SERVICE BULLETIN

PRODUCT JH-110 RECORDERBULLETIN NO. 202**SERVICE BULLETIN**DATE APRIL 29, 1976P.C. BD. POWER HARNESS No. _____ECO NO. 162 IN NEW PRODUCTION April 20, 1976

PRODUCT JH-110 RECORDER

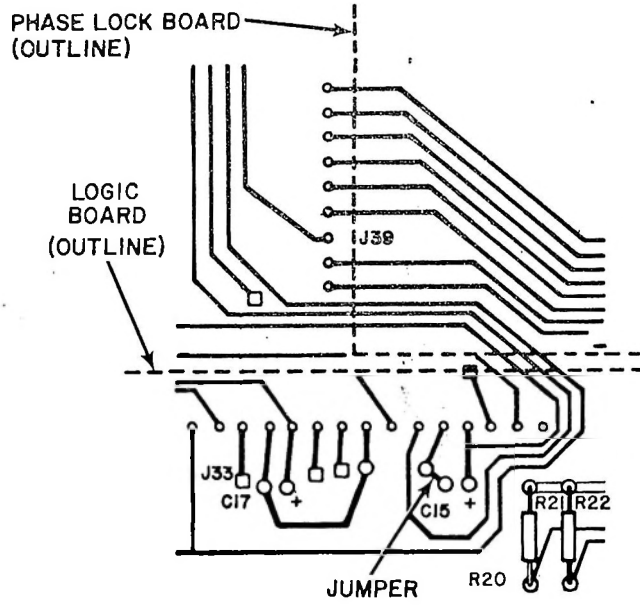
Add 22ga wire from negative side of capacitor C15 (under Logic Board) to ground as shown in illustration on reverse side.
